# Citizens Committee For ~~Hurricane~~ Flood Control

Re: 1962 Master Plan for  
Hurricane Flood Control

### Proposed Changes in U. S. Army Corps of Engineers Flood Control Plans - New Orleans Area

**PLAN OF PROTECTION AS  
PROPOSED BY U.S. ARMY  
ENGINEERS.**

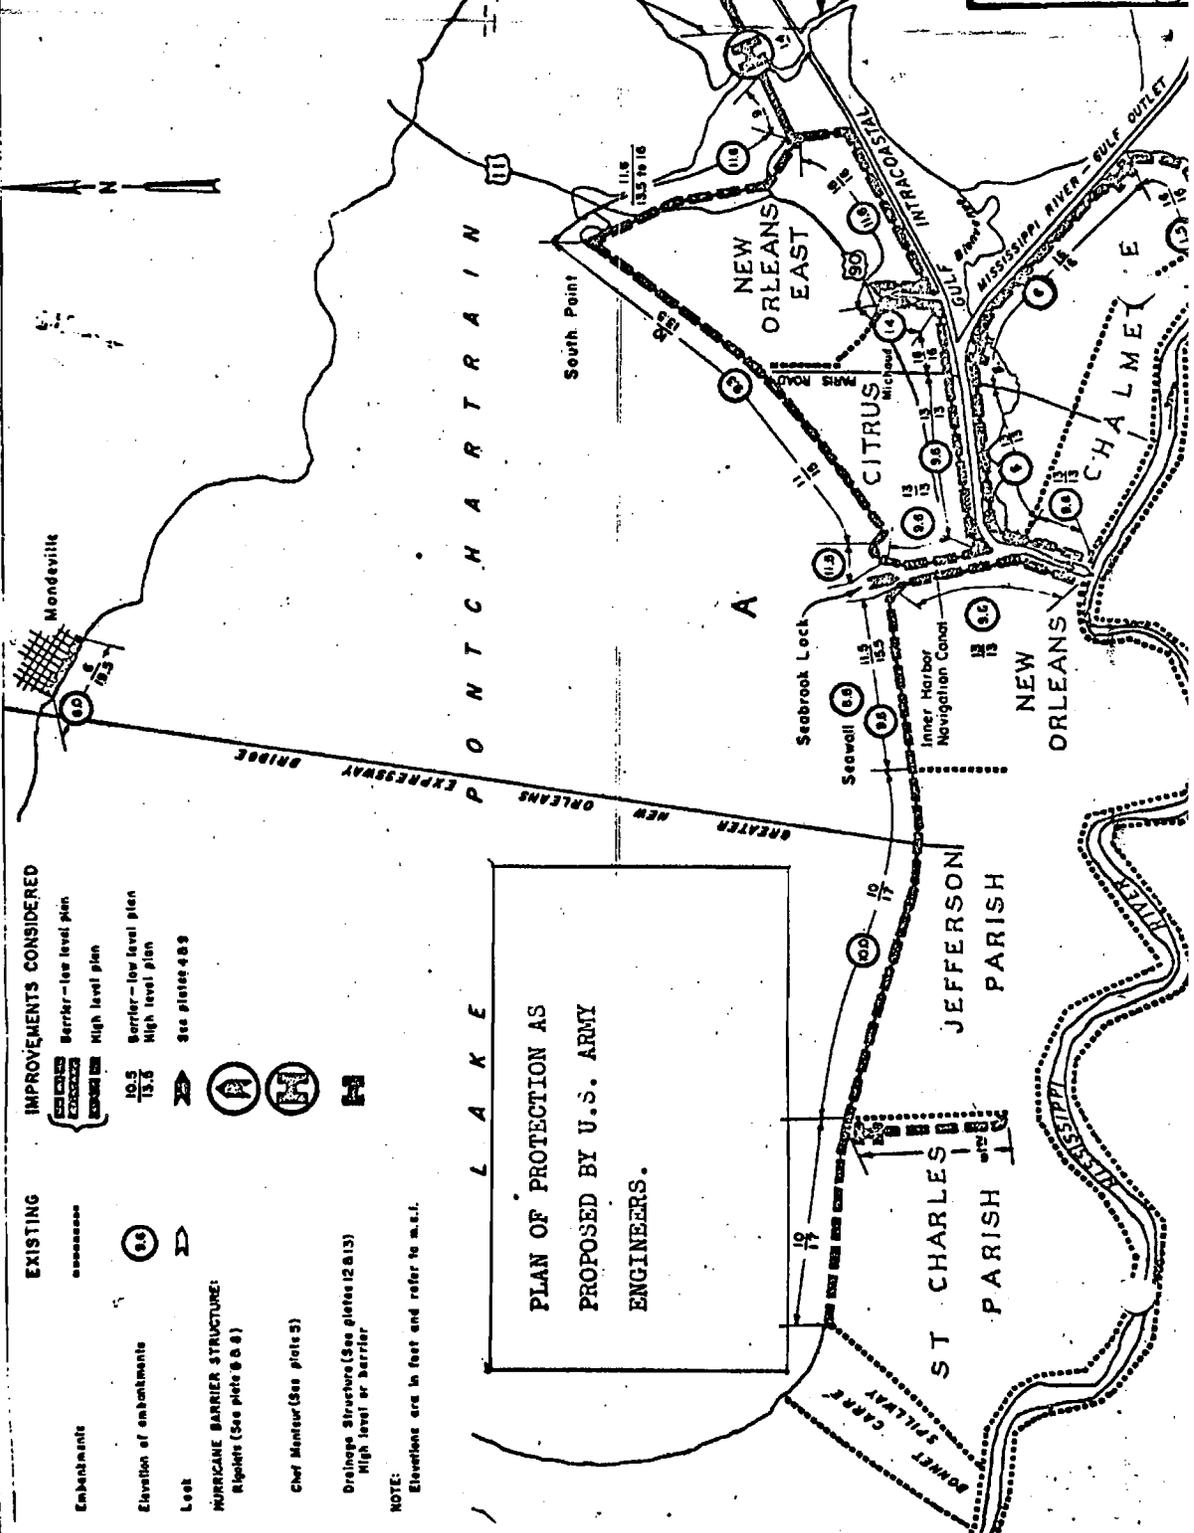
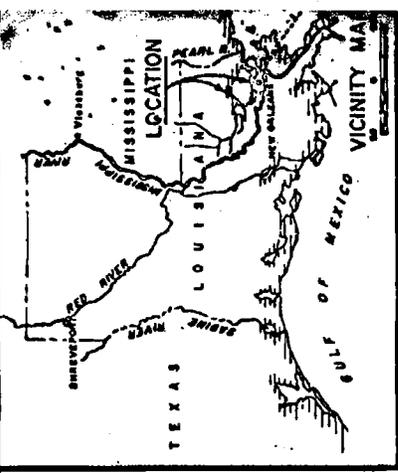
- A. Eliminate the proposed Seabrook Locks in their entirety and replace with flood gates.
- B. Construct flood gate across Intercoastal Waterway at south end of New Orleans East Levee.

- C. Construct flood gate across Bayou Bienvenue near entrance of Lake Borgne.
- D. Construct flood gate across Mississippi River Gulf Outlet at north end of Chalmette Levee along Bayou Dupre.

- E. Construct a new levee, 30 ft. in height, connecting flood gates on Miss. Gulf Outlet to gates on Bayou Bienvenue and gates on Intercoastal Canal.
- F. Raise the height of the 16-ft. New Orleans East Levee from the Intercoastal Waterway to its intersection with the Barrier Levee along Highway 90 to 30 feet.

- G. Raise the height of the 16-ft. Chalmette Levee from the Mississippi Gulf Outlet, along Bayou Dupre to its intersection with the Mississippi River embankment, to 30 feet.

- H. Eliminate in its entirety the two proposed drainage structures on the Chalmette Levee near Bayou Dupre and near intersection of Mississippi Gulf Outlet and Intercoastal Canal.

The need for these costly (\$4,980,000) locks would be eliminated when the flood gates at Chef Menteur, Rigolets, and our proposed levee and flood gates at the Intercoastal Waterway, Bayou Bienvenue, and Mississippi Gulf Outlet are in place. With these structures closed the Lake and Canal level should remain the same. Our proposal for installing flood gates at Seabrook is to stop wind driven waters from the Lake into the Industrial Canal as hurricane winds shift to the north.

The U. S. Army Engineers proposal for a levee along the south shore of the Gulf Outlet to Bayou Dupre, and along the north shore of the Intercoastal Waterway would form a funnel, channeling all hurricane surges and wind driven water into the Intercoastal Waterway and Industrial Canal. Construction of flood gates at points outlined in Revisions B, C, D, and connected by the new 30-foot levee outlined in Revision E, would completely eliminate the funnel effect and stop all storm and hurricane surges from entering the city.

The raising of these levees from 16 feet to 30 feet would complete the barrier to stop all surges from entering the developed areas of New Orleans and Chalmette.

The Army Engineers' proposal to construct two drainage structures in the Chalmette Lev

if the opinion of this committee, will be unnecessary when the three new flood gates and a levee are completed.
